Staff Report Z-74-21-2 January 6, 2022

North Gateway <u>Village Planning</u> <u>Committee</u> Meeting Date:	January 13, 2022
Planning Commission Hearing Date:	February 3, 2022
Request From:	<u>C-2 M-R NBCOD</u> (18.81 acres)
Request To:	<u>C-2 HGT/WVR DNS/WVR NBCOD</u> (18.81 acres)
Proposed Use:	Multifamily residential
Location:	Northwest corner of the 29th Avenue and Bronco Butte Trail alignments
Owner:	Plas North Valley Land, LLC
Applicant	Bond Companies
Representative	Wendy Riddell, Berry Riddell, LLC
Staff Recommendation:	Approval, subject to stipulations

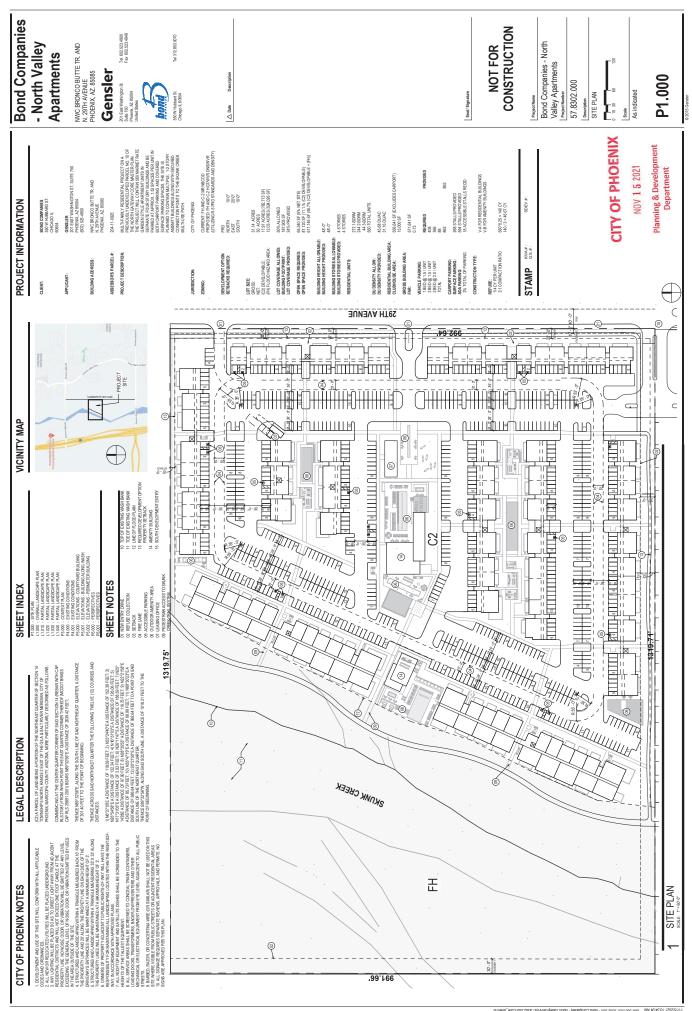
Staff does not recommend general conformance to the conceptual site plan provided by the applicant to avoid future conflicts with a Street Transportation Department stipulation requiring the developer to align driveways with the site(s) on the east side of 29th Avenue.

Staff is recommending Stipulation No. 1 regarding utilization of the R-5 Planned Residential Development Option. Staff is also recommending Stipulation No. 2

to limit the maximum number of dwelling units to 560 as depicted in the conceptual site plan. Furthermore, staff is recommending Stipulation Nos. 3 and 4 regarding landscape setback enhancements along the western side of the site and a greater open space percentage given the absence of public parks in the immediate area. Staff is also recommending Stipulation No. 5 to ensure the development provides a greater number of amenities due to the number of units proposed on the site. Lastly, staff recommends Stipulation No. 6 to ensure no parking is located directly adjacent to Skunk Creek Wash to help create a pedestrian environment along the wash corridor.
